NORTHEAST UTILITIES

Millstone Nuclear Power Station, Unit No. 3
Meeting Summary of NRC Structural Audit
Transmittal of Responses to Confirmatory Items

STATUS OF STRUCTURAL AUDIT DISCUSSION ITEMS
INCLUDING DSER OPEN ITEMS
AND 220 SERIES QUESTIONS

FIGURE 3.7B-9
DYNAMIC MODEL OF
THE CONTAINMENT STRUCTURE
MILLSTONE NUCLEAR POWER STATION
UNIT 3
FINAL SAFETY ANALYSIS REPORT

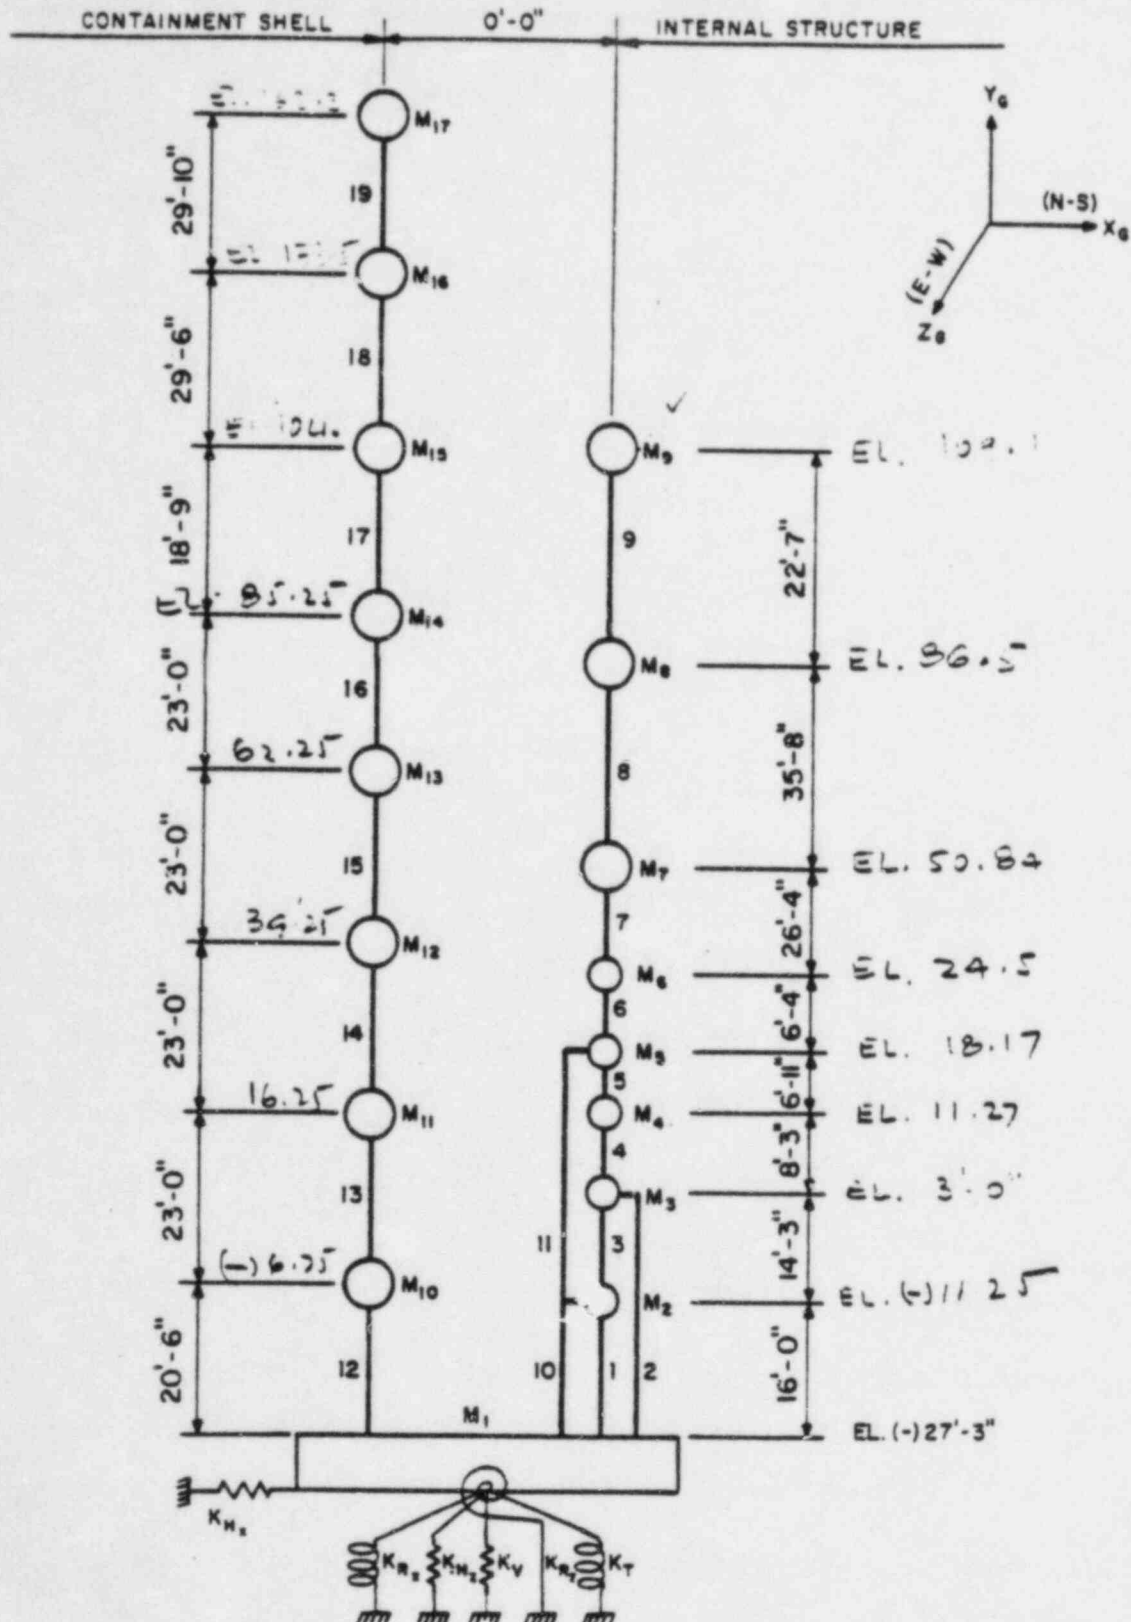
ITEM 9 Provide comparison of development of torsional constants using computer program SECPROP versus classical shell theory for crane wall. This issue was resolved. Applicant will provide this response.

A comparison was made between the torsional constants developed using Secprop 3 vs classical shell theory for the members of the dynamic model of the containment structure representing the internal structure. This comparison is presented in Table 1. Since a large difference is evident between the two methods for members 7 and 8, the containment dynamic model was rerun with revised torsional stiffness for members 4 through 8 based on the torsional constants developed from shell theory. A comparison of resulting frequencies and responses for the original and revised model are presented in Tables 2 and 3. It is clear from this comparison that no significant change in response resulted due to the change in torsional stiffness, therefore demonstrating that the original containment dynamic model is an adequate representation of the actual building.

SOIL-STRUCTURE INTERACTION EMERGENCY GENERATOR ENCLOSURE

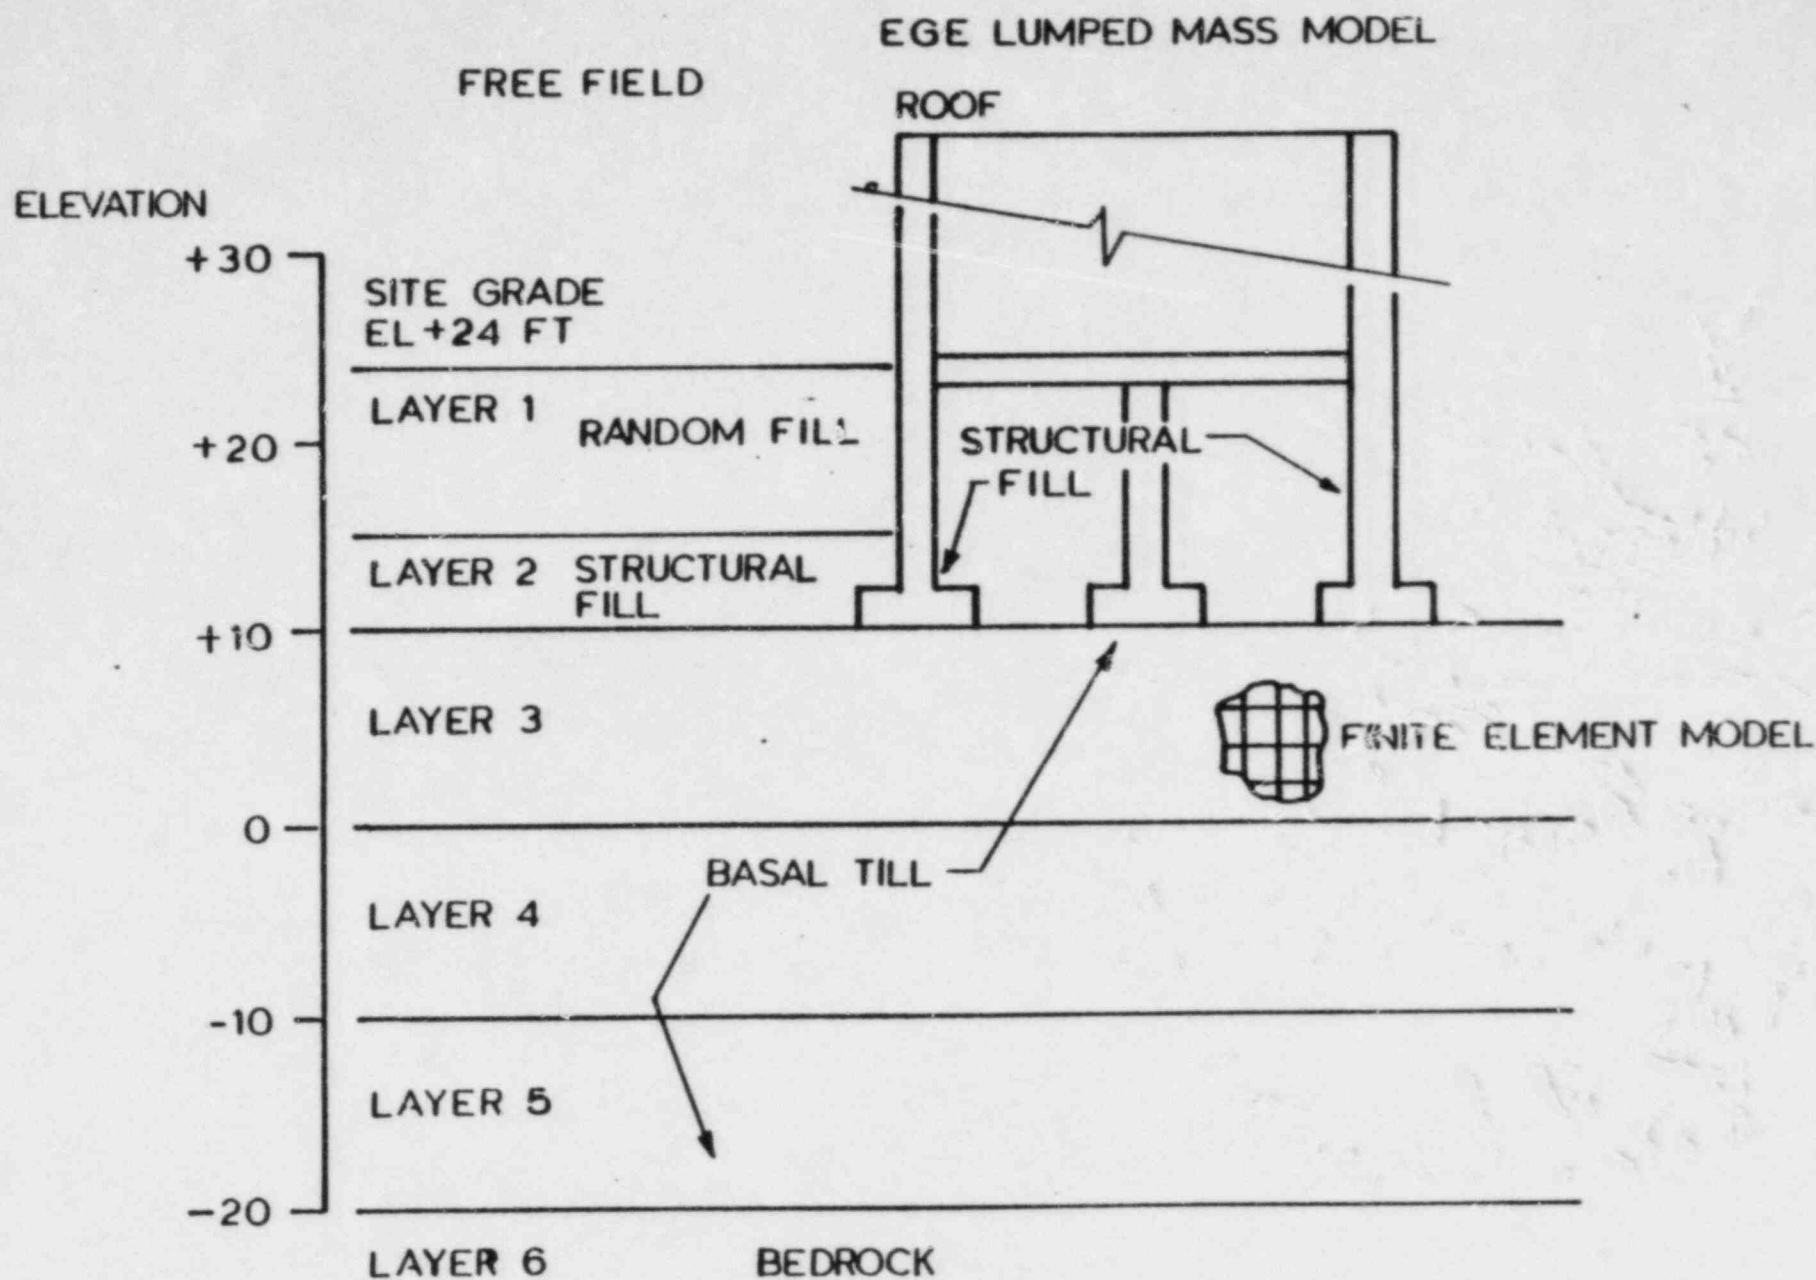
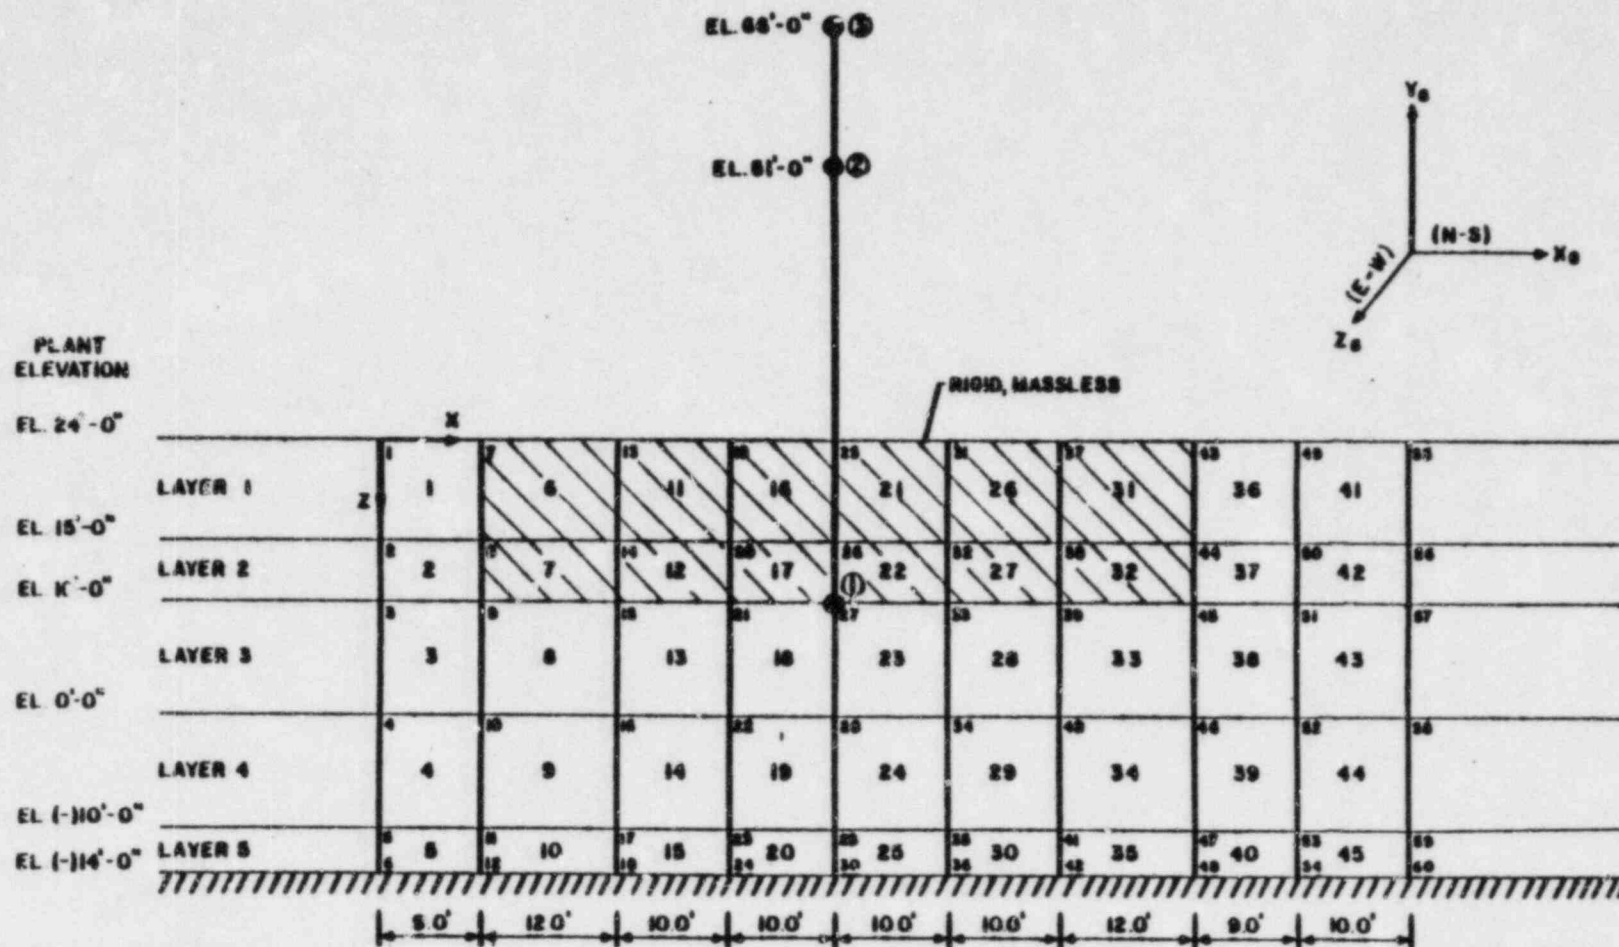
ITEM 12 Show how the 2 degree-of-freedom Plaxly soil element is transferred into a rotational input for the lumped mass structural model. Demonstrate how the control building was considered in the soil model. Provide a description similar to EGE building for control building showing soil structure interaction. Provide a description on the modified halfspace analysis. A discussion of the above items was presented and the issue was resolved. The Applicant will provide this response.

A group of elements representing the building within the finite element grid are given properties of a very rigid and massless body. (See Figure 3.7B-11). The lumped mass model of the structure containing 3 degrees-of-freedom per lumped mass (i.e., horizontal, vertical and rotational) is then coupled to the finite element grid at the nodal point representing the contact area center between the building and subgrade. Since the mat is modeled as a rigid body, vertical displacements along this interface line between the subgrade and mat are transferred into a rotation about the contact center representing the first lumped mass of the structure. The result is a rotational response of the lumped mass which is transmitted up into the lumped mass stick model of the structure. (See Figure 2).

The effect of the control building in the seismic response analysis of the emergency generator enclosure was considered as follows. An equivalent soil mass was calculated to represent the control building (elements 41, 42 and 43 of FSAR Figure 3.7B-11). An equivalent density based on the total mass of the building divided by the displaced volume of soil was calculated and used for these elements. Based on the fundamental frequency of the building and the depth of soil displaced by the structure, an equivalent shear modulus was calculated and used for these elements, as indicated on the following pages.

FIGURE 37B-9

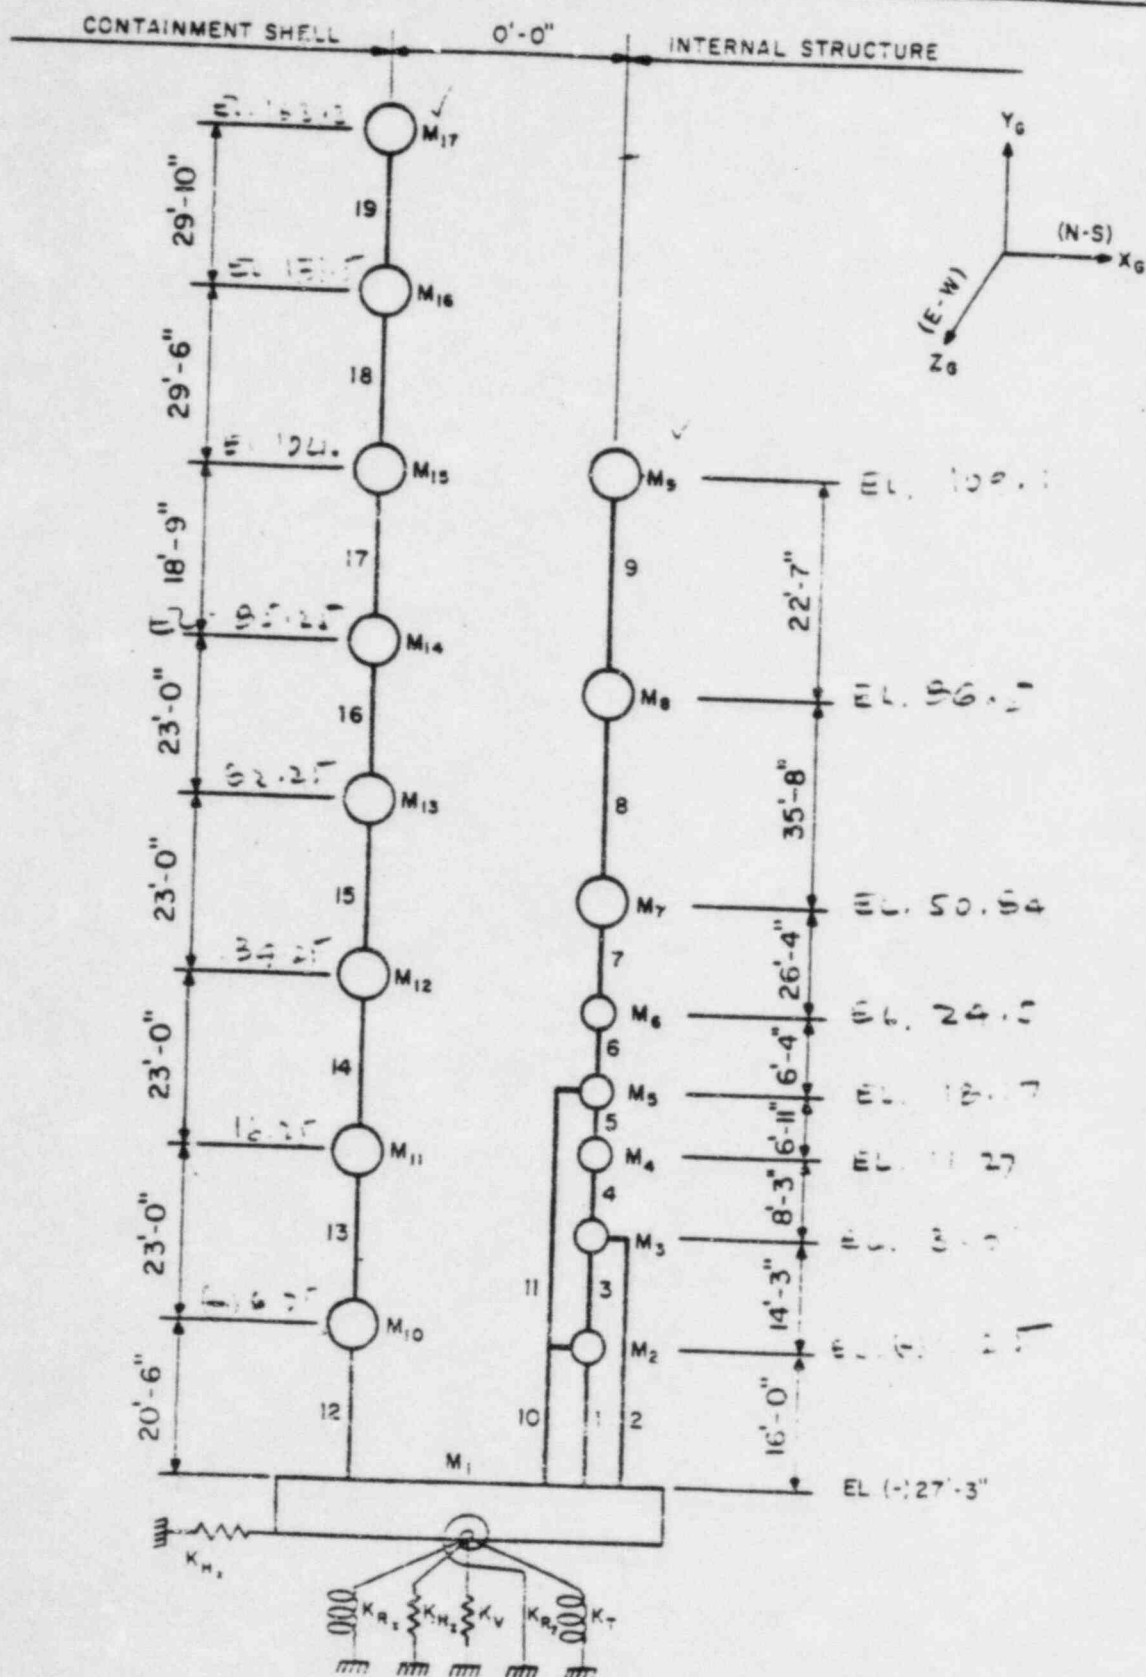
Item 13	Indicate how the effect of the NSSS systems were accounted for in the seismic evaluation, of internal structures.	Confirmatory
Item 14	Provide a detailed discussion on how the CM and CR are considered in development of stiffness matrix.	Confirmatory

The internal structure seismic model (Figure 3.7B-9, Building Model) is combined with the 4-loop reactor coolant system (RCS) model as shown in the attached Figure 1. In this model, the numbers in circles and triangles represent the building stick model springs and mass points. Node Numbers 73, 74, 75, and 76 represent the RCS model's connectivity to building model mass points.
